Former Akzo Nobel Site, Hollingworth Road, Littleborough

For above outlined site which comprises Areas A and C, we have undertaken a high level review of the following documents:

CELTIC's Outline Foundation Option Plan, dated February 2008, reference P10008/09001/10

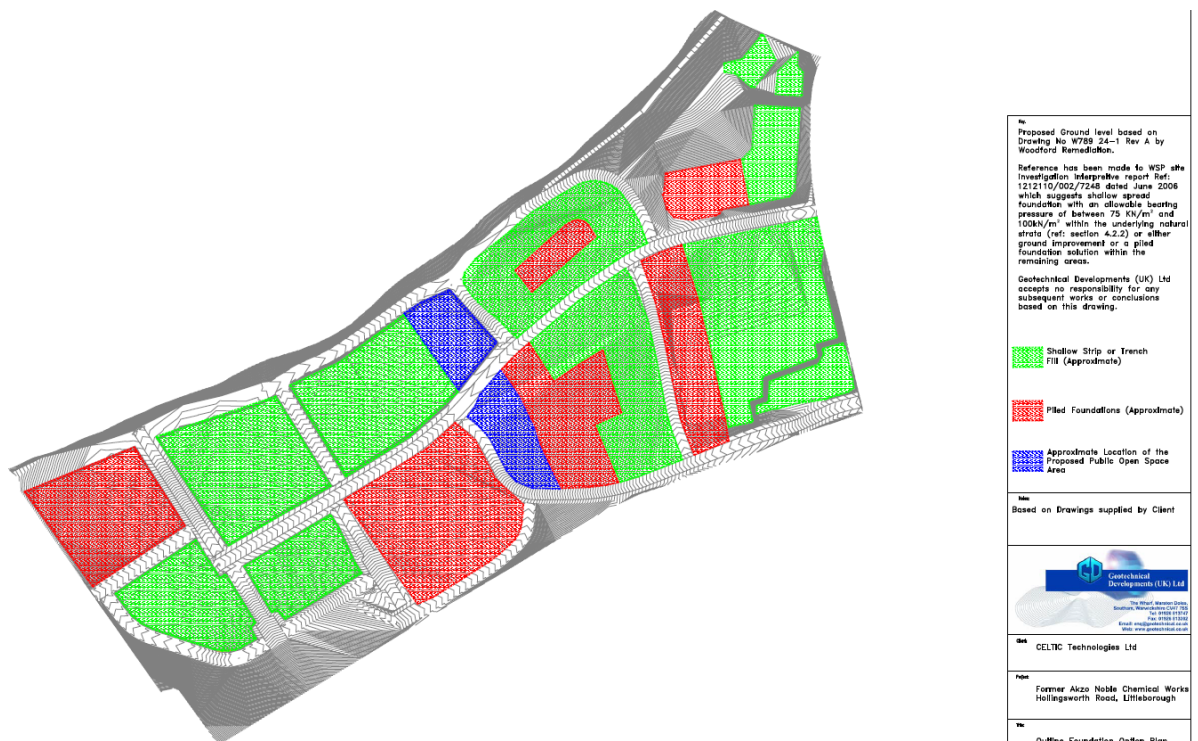
The plan notes the 2006 WSP allows for a safe bearing pressure of 75 to 100 kPa in natural strata. The areas where 'shallow strip and trench fill' footings are expected to be appropriate are shaded in green, whilst piled foundations are in red. Blue is POS area (designated at that time):
